## WGSL Sedimentation Basin Restoration Addendum Report

Subject: Sedimentation Basin Restoration Observation Report Addendum, Waimanalo  
Gulch Sanitary Landfill, Kapolei, HI

“Punch List” for Restoration of Sedimentation Basin at Waimanalo Gulch Sanitary Landfill  
(paragraph 19.h. of the January 2011 AOC between WMH and EPA)

Prepared by EPA Region 9, 28 June 2011

**3 DETENTION POND SUBDRAIN DETAIL**  
C-11 NO SCALE

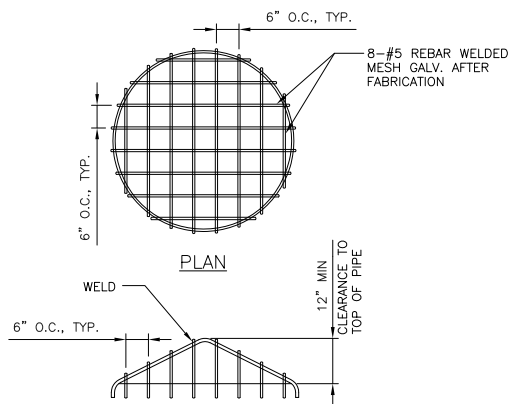
- 6) In performing the restoration 4-inch diameter perforated HDPE pipe was used in the subdrain rather than the 6-inch noted in the design drawings because the existing (“as-built condition”) was found to be 4-inch pipe. Please provide either an engineering analysis that confirms this change in pipe size is adequate to conform to the original design basis, or replace the 4-inch diameter pipe with the 6-inch size included in the approved Work Plan.

The 4-inch perforated high-density polyethylene (HDPE) subdrain pipes originally installed in the southern portion of the basin area were replaced with 6-inch perforated HDPE pipes, as shown on Drawing C-11 provided in the work plan (Attachment 1). The replacement pipes were 6-inch SDR-11 HDPE pipes and were perforated with 5/16-inch holes every 6 inches, offset 90 degrees, with holes on the top, bottom, and both sides of pipe.

During replacement of the 4-inch subdrain pipes, the pipe trenches were excavated and the existing pipes and 16-ounce per square yard (oz/yd<sup>2</sup>) filter geotextile removed and disposed of on site. The 3/4-inch drainage gravel was stockpiled for re-use. Following excavation of the 4-inch subdrain system, the floor of the subdrain trenches were re-graded for proper drainage to the concrete riser vaults and new 16-oz/yd<sup>2</sup> filter geotextile installed. The drainage gravel and perforated 6-inch HDPE pipes were installed as shown on Detail 3 on Drawing C-11 provided in the work plan (Attachment 1).

**2 DETENTION POND BERM**  
C-11 NO SCALE

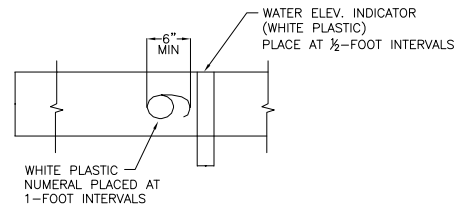
- 5) Based on EPA staff’s observations and Photos 31 and 32 of AECOM’s report, it appears the removal of sediment and inspection/repair of riprap armoring the interior berm might not have been thoroughly completed. Please fully uncover, inspect and repair any damaged or missing riprap on the interior berm per the GEI Work Plan. Additionally, from what was observable, the detention pond’s interior berm dimensions do not appear to coincide with those shown in Detail 2 on Drawing C-11; please restore accordingly.

Following replacement of the subdrain system, the interior retention berm was restored as shown on Detail 2 of Drawing C-11 provided in the work plan (Attachment 1). Restoration included installation of a 12-inch thick grouted rock rip-rap (GRP) on the exterior of the berm. Prior to installation of the GRP, a D6 dozer and an excavator were used to grade the interior of the berm and expose the 2-foot deep keyway on the northern/southern sides of the berm for the GRP.
